STATE OF WASHINGTON
DEPARTMENT OF ECOLOGY

Re: Opinion on Proposed Cleanup of the following Site:

- **Site Name:** Tarr LLC Vancouver Cardlock
- **Site Address:** 7208 Northeast St. Johns Road, Vancouver, Washington 98665
- **Facility/Site No.:** 82645316
- **VCP Project No.:** SW1174

Groundwater Concentrations

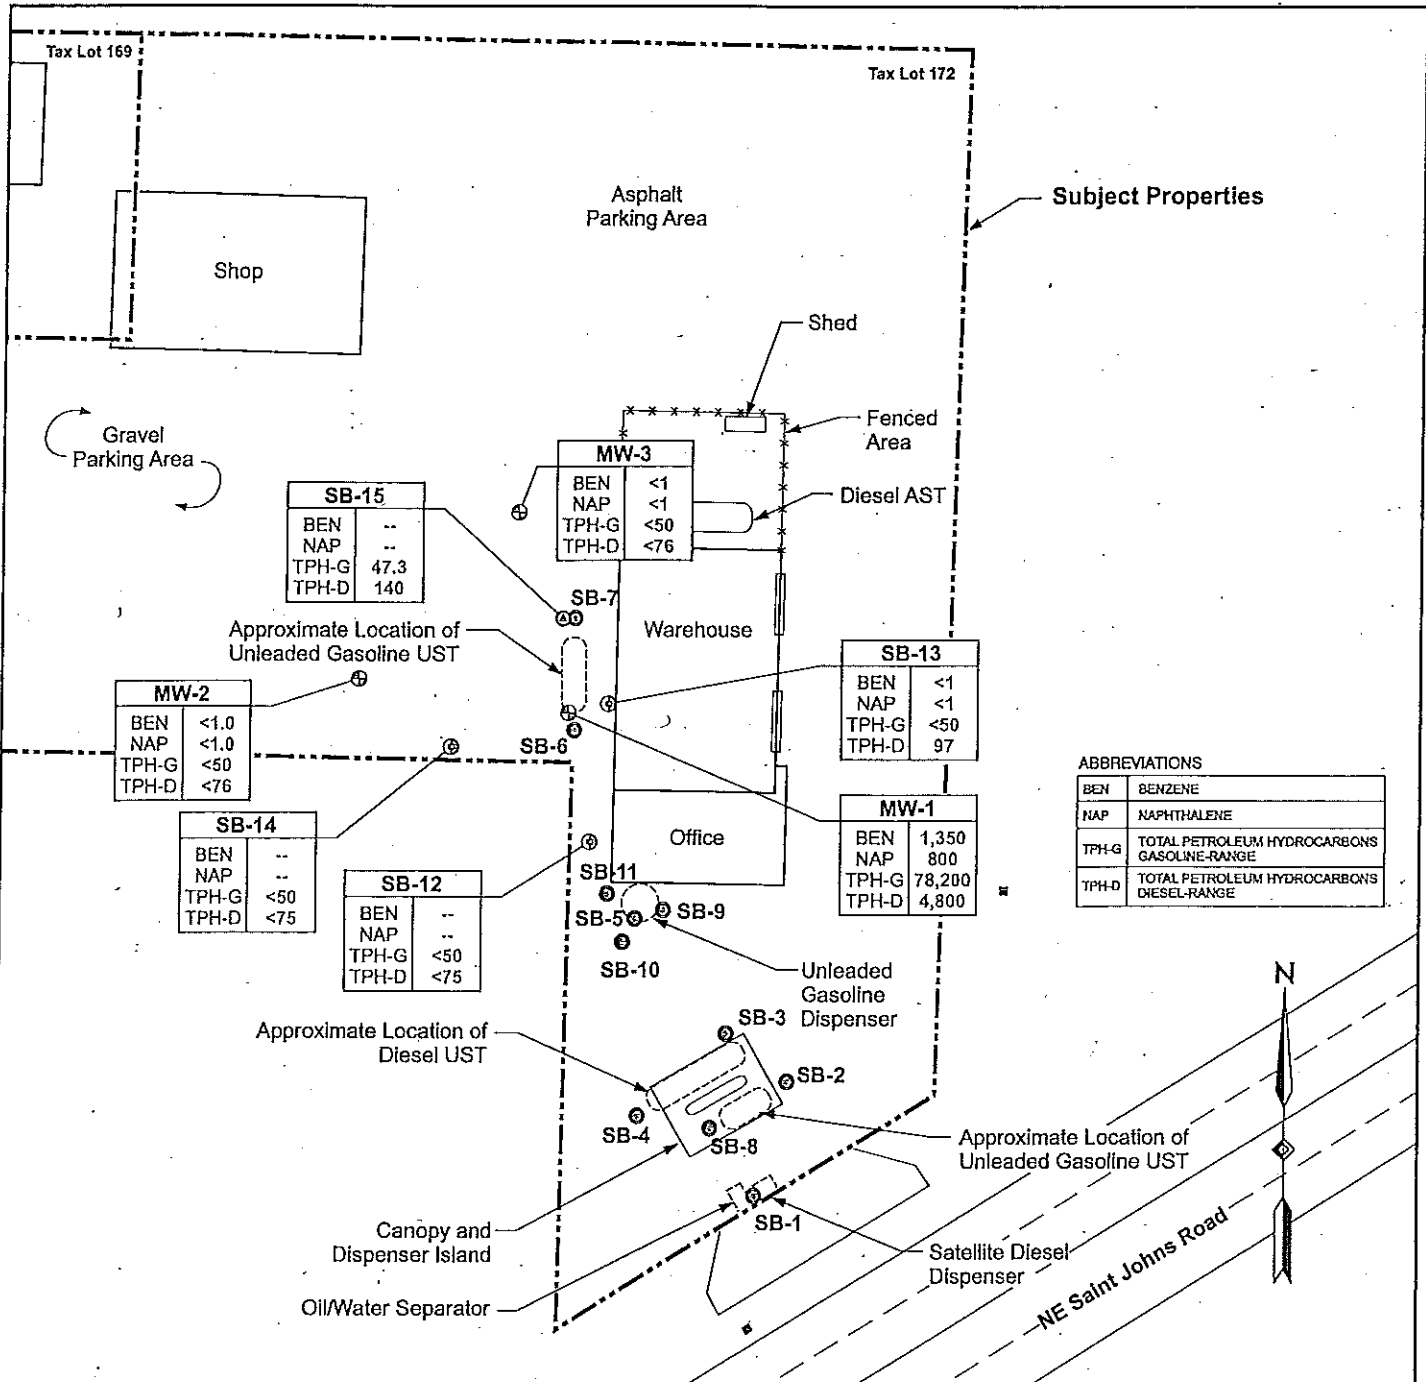
The monitoring wells were installed to a maximum depth of 18 feet bgs. The monitoring wells were installed around the lone gasoline UST on the west side of the warehouse where soil analytical results indicated soil contamination (see Figure 4). The groundwater was analyzed for TPH-G, TPH-D, TPH-O, PAHs, VOCs, and total lead. Groundwater analytical results indicated TPH-G, TPH-D, benzene, ethylbenzene, and total xylenes were the only COCs above their respective MTCA Method A Groundwater CUL in monitoring well MW-1 (see Figure 5 and Table 3).

1. Since the source of the SB-5 soil contamination appears to be a separate source from the MW-1 soil and groundwater contamination, Ecology recommends that the groundwater below SB-5 be evaluated for TPH-G, TPH-D, TPH-O, PAHs, BTEX, EDB, EDC, MTBE, and total lead. If contamination is identified, then this area will need to be incorporated into your cleanup action, and the installation of additional permanent wells to monitor compliance may be needed.
2. Since TPH-G soil concentrations were 10,700 milligrams per kilogram at MW-1, Ecology recommends a vapor intrusion preliminary assessment be completed for impacts to indoor air at the Site per WAC 173-340-740(3)(C)(I). Also, benzene groundwater concentrations at MW-1 of 940 micrograms per liter ($\mu\text{g/L}$) exceeded the MTCA Method B groundwater screening level of 2.4 $\mu\text{g/L}$ identified in Table B-1.
